SERVICE ALERT

#0012 Revision 2

SUBJECT: Sub-standard high pressure rubber fuel hose rupturing between

MODELS AFFECTED: All Rotax 912 iS, 915 iS and 916 iS fitted Sling ready to fly aircraft

Figure 4: 912 iS Fuel System Diagram

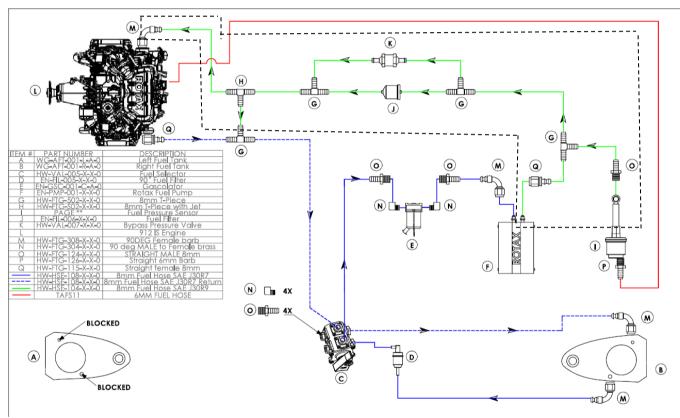
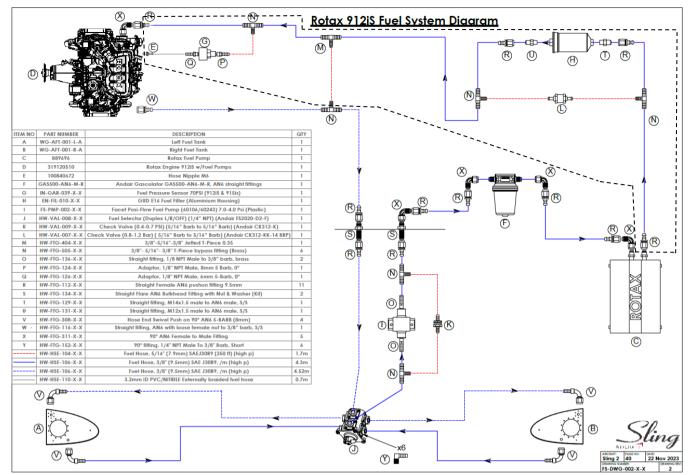
With reference to Figure 4 and Figure 5, all the fuel lines bounded withing the dashed line "----" must be inspected and replaced should they be of the sub-standard type of fuel hose. It must be replaced with the correct fuel hose as described in Section 2.

- Step 1: In order to inspect the fuel lines shown in the diagrams above, remove the cowling. Refer to Section 5.1.1 of the Sling 2 & LSA Maintenance Manual for the instructions to remove the cowling.
- Step 2: The heat sleeve around the fuel hose will be fixed in place using either locking wire or metal cable ties. Once the cowling has been removed, used the side cutters to remove these so that the heat sleeve can be moved to inspect the hose underneath. Refer to Figure 6 for an example of how the heat sleeve is attached using the cable ties. Please note, Figure 6 is just for reference purposes, all the fuel lines (as shown in Figure 4 and Figure 5.) must be checked.

Figure 7: 915 iS Fuel System Diagram

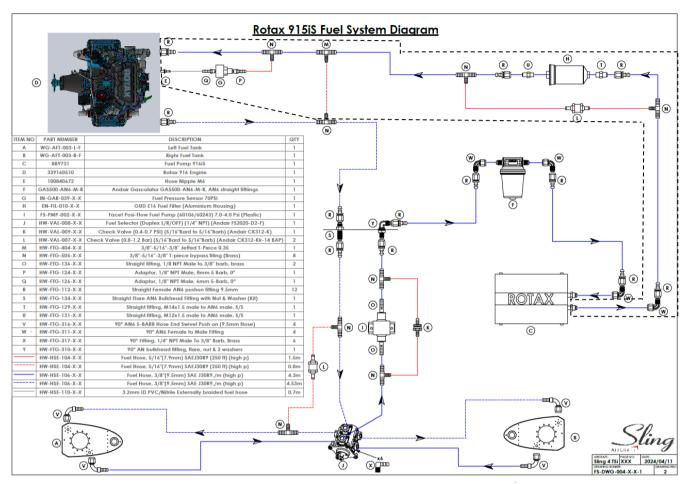
With reference to Figure 7, all the fuel lines bounded withing the dashed line "----" must be inspected and replaced should they be of the sub-standard type of fuel hose. It must be replaced with the correct fuel hose as described in Section 2.

- Step 1: In order to inspect the fuel lines shown in the diagram above, remove the cowling. Refer to Section 5.1.1 of the Sling 4 TSi Maintenance Manual for the instructions to remove the cowling.
- Step 2: The heat sleeve around the fuel hose will be secured in place using either locking wire or metal cable ties. Once the cowling has been removed, used the side cutters to remove these so that the heat sleeve can be moved to inspect the hose underneath. Refer to Figure 8 for an example of how the heat sleeve is attached using the cable ties. Please note, Figure 8 is just for reference purposes, all the fuel lines (as shown in Figure 7) must be checked.

Figure 9: 916 iS Fuel System Diagram

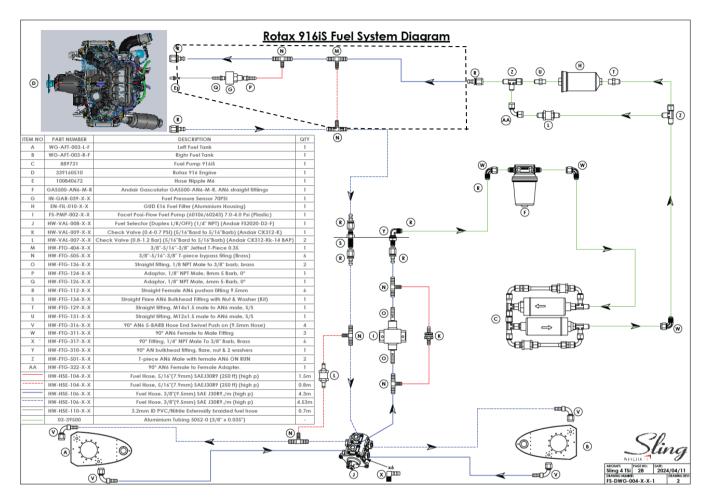
With reference to Figure 7, all the fuel lines bounded withing the dashed line "----" must be inspected and replaced should they be of the sub-standard type of fuel hose. It must be replaced with the correct fuel hose as described in Section 2.

- Step 1: In order to inspect the fuel lines shown in the diagram above, remove the cowling. Refer to Section 5.1.1 of the Sling 4 TSi Maintenance Manual or the Sling 4 High Wing Maintenance Manual (where applicable) for the instructions to remove the cowling.
- Step 2: The heat sleeve around the fuel hose will be secured in place using either locking wire or metal cable ties. Once the cowling has been removed, used the side cutters to remove these so that the heat sleeve can be moved to inspect the hose underneath. Refer to Figure 8 for an example of how the heat sleeve is attached using the cable ties.
